MONTGOMERY COUNTY HISTORIC PRESERVATION COMMISSION
STAFF REPORT

Address:	5906 Cedar Parkway, Chevy Chase	Meeting Date:	7/28/2021
Resource:	Contributing Resource (Chevy Chase Village Historic District)	Report Date:	7/21/2021
		Public Notice:	7/14/2021
Applicant:	Scott Talbott (Luke Olson, Architect)	Tax Credit:	N/A
Review:	HAWP	Staff:	Michael Kyne
Case Number:	958818		
PROPOSAL:	Demolition and new construction, driveway, and other alterations

Staff recommends that the HPC **approve** the HAWP application.

Fig. 2: 1927 Sanborn Fire Insurance Map, depicting the subject property. The garage to be demolished is circled in red.

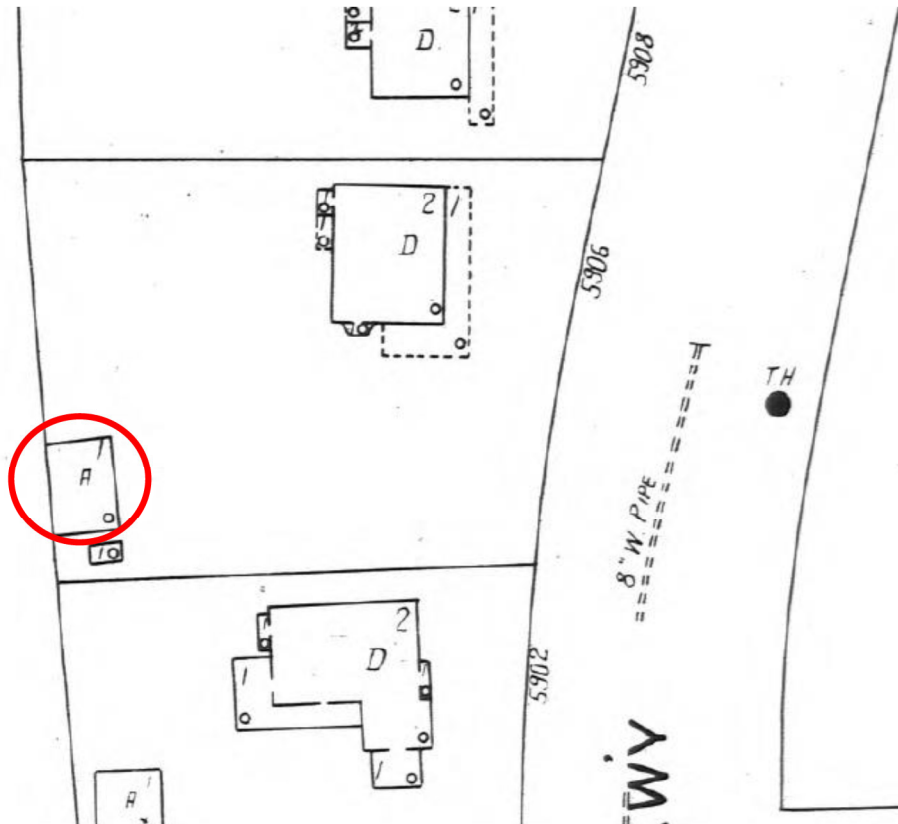
According the 1927 Sanborn Fire Insurance Map (see *Fig. 2* below), the existing garage to be demolished is original to the historic house. However, the garage appears to have experienced previous alterations, and its location and relationship to the historic house is atypical within the Chevy Chase Village Historic District. Accordingly, staff finds that the removal of the garage will not remove or alter character defining features of the historic district or surrounding streetscape, per *Standards* #2 and #9.

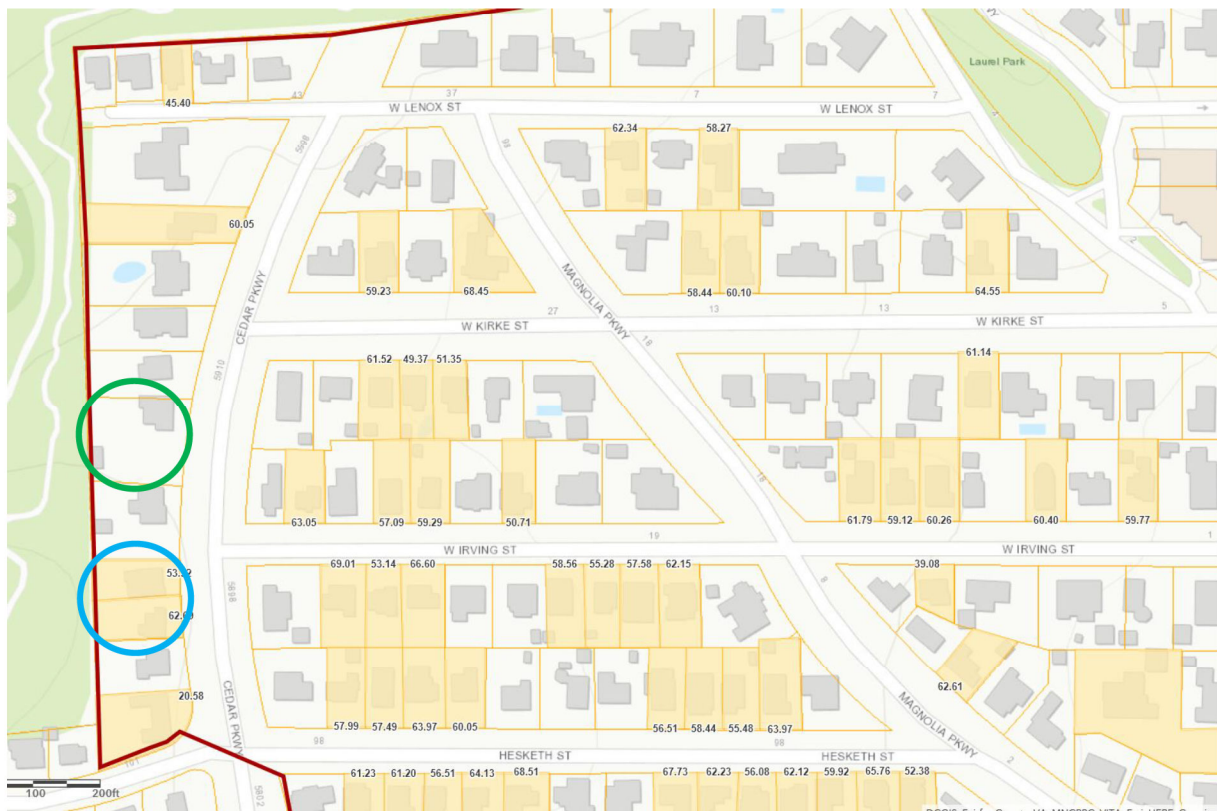
The applicant has also provided a letter from Chevy Chase Village, stating that the Village's requirement for lots to have a minimum frontage of 75' does not apply to these two parcels (each measuring approximately 70'), and subdivision of the property and construction of a new dwelling would be in compliance with the Village's frontage requirements. In consultation with the Montgomery Planning GIS team, staff determined that 117 (or approximately 36%) of the 327 properties within the Chevy Chase Village Historic District have a frontage of 70' or less. Four properties on Cedar Parkway have a frontage of less than 70', including nearby 5808 (62.69') and 5810 Cedar Parkway (53.52'). A partial image from the GIS map showing properties with a frontage of 70' or less is below (*Fig. 3*). The full map is also available at the following link: <https://arcg.is/1Wu8r5>

Fig. 5: Streetscape study of the proposed house and adjacent houses to the north and south, as provided by the applicant.

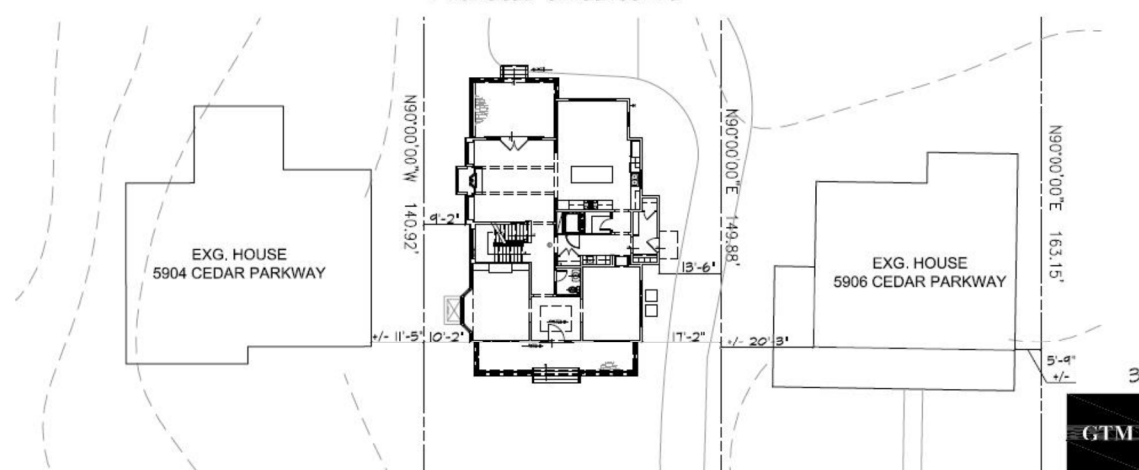
Regarding scale and massing, staff's GIS estimates indicate that the adjacent 2 ½-story house to the south (5904 Cedar Parkway) is approximately 58' wide by 60' deep (at its deepest point), and the existing 2 ½-story subject property house (to the north of the proposed new house) is approximately 47' wide by 45' deep (beginning at the covered front porch). This, along with the submitted streetscape study, demonstrates the general compatibility in scale and massing of the proposed 2 ½-story, 35'-11" wide by

53'-3" deep (not including projecting bays or porches) house. This is further supported by the footprint study of the immediate surrounding area, which depicts an even greater variety in scale and massing.

Fig. 6: Infill construction at 2 West Melrose Street (constructed 1999), as indicated by the blue star.

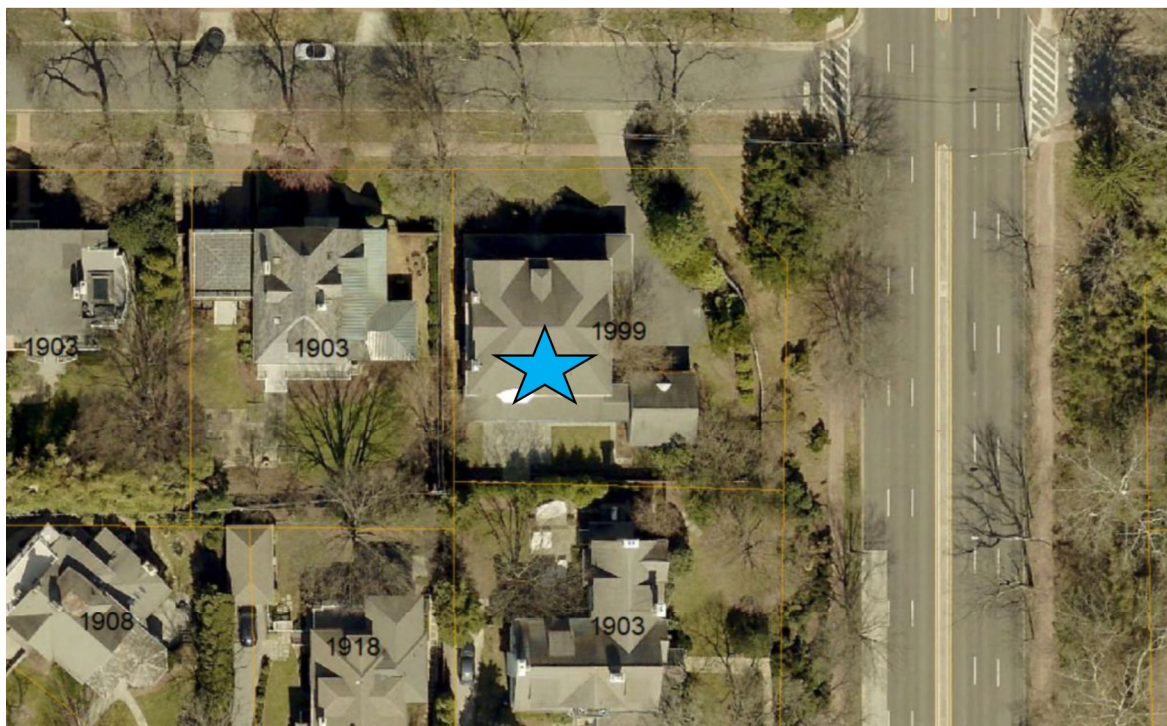
The 2 ½-story house at 2 West Melrose Street (see *Fig. 6* below) was constructed via an approved HAWP in 1999 on a historically vacant corner lot (corner of West Melrose Street and Connecticut Avenue), which was associated with the Outstanding Resource at 6000 Connecticut Avenue. A non-historic pool house and swimming pool on the vacant lot were demolished prior to construction of the new house. Staff's GIS estimates indicate that the infill house is approximate 66' deep (at its deepest point) by 53' wide. The records for this case can be found at the following link:

Fig. 7: Infill construction at 1 Newlands Street (constructed 2001), as indicated by the blue star.

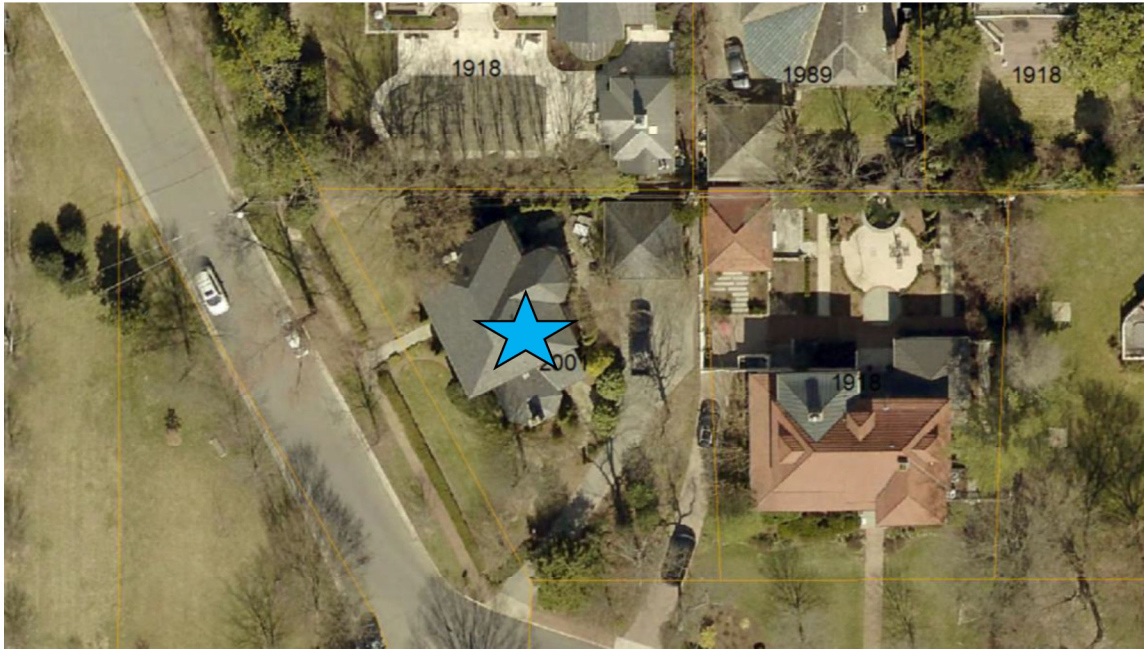
Similarly, the 2 ½-story house at 1 Newlands Street (see *Fig. 7* below) was constructed via an approved HAWP in 2001 on a historically vacant lot associated with the Contributing Resource at 3 Newlands Street. As in the current proposal, the existing driveway at 3 Newlands Street was utilized to access a proposed new garage at the infill property, with a new driveway later approved at 1 Newlands Street. Staff's GIS estimates indicate that the infill house is currently approximately 46' deep by 56' wide at its deepest and widest points. The records for this case can be found at the following link:
